METROPOLITAN GOVERNMENT OF NASHVILLE AND DAVIDSON COUNTY

Metropolitan Historic Zoning Commission
Sunnyside in Sevier Park
3000 Granny White Pike
Nashville, Tennessee 37204
Telephone: (615) 862-7970
Fax: (615) 862-7974

STAFF RECOMMENDATION
215 Broadway
March 18, 2020

Application: New Construction - Violation
District: Broadway Historic Preservation Zoning Overlay
Council District: 19
Base Zoning: DTC
Map and Parcel Number: 093 06 4 043.00
Applicant: Broadway Hotel, LLC
Project Lead: Jenny Warren, jenny.warren@nashville.gov

Figure 1: 215 Broadway in March 2020

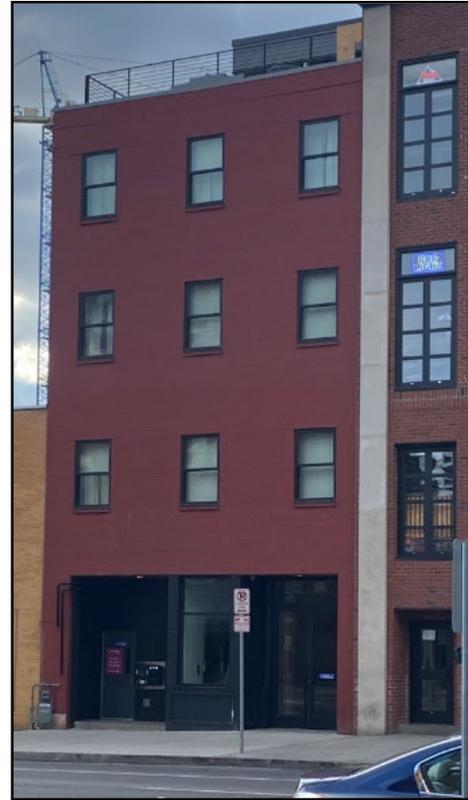
The original storefront was replaced at some point prior to the overlay. In 2014, MHZC approved changes to this storefront in conjunction with permits for the Moxy Hotel. The storefront was altered as a part of the Moxy rehabilitation, but the final storefront design does not match the permits. An ATM has also been installed in the front of the building on the left side.

The entry was temporarily boarded in 2016 and an ATM was added at that time. They receive notice to remove the ATM in July of 2016 and removed it several months later.

Figure 5: Aerial picture. 215 Broadway indicated by pin. The entrance to the Moxy Hotel is in a separate but connected building, along 3rd Avenue, North.

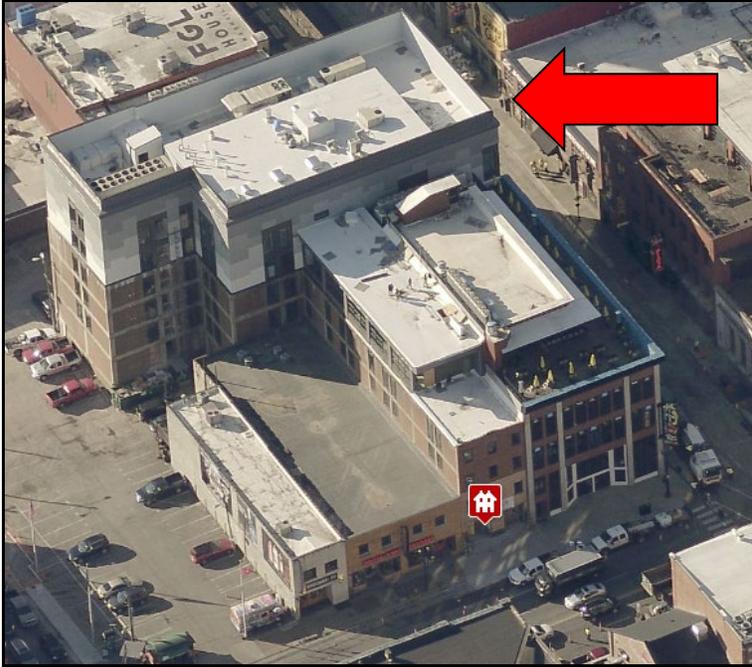
In addition to not meeting the design guidelines for new construction, the ATM does not meet the policy the Commission established in 2004 that only allows for ATMs inside a building, where it would not be reviewed, or “in an alcove not on the primary facade.” This ATM is in a recessed primary entry rather than an “alcove,” and it is located along Broadway, one of the most highly visible streets in the district. The Moxy Hotel occupies the property today and operates out of this historic building and a second building behind it, which faces onto 3rd Avenue, South. While the Moxy has their primary entrance on 3rd Avenue, Broadway is still the primary façade for this historic building. Therefore, an ATM along this primary façade is not appropriate.

Staff recommends disapproval of the current storefront configuration including the ATM, finding that it does not meet Section II of the design guidelines for rehabilitation, Section III of the design guidelines for new construction and the MHZC policy for ATMs. Staff suggests that the doors and transoms be installed into the left side of the storefront, as per the plans approved in 2014 and the ATM be removed within the next 60 days.
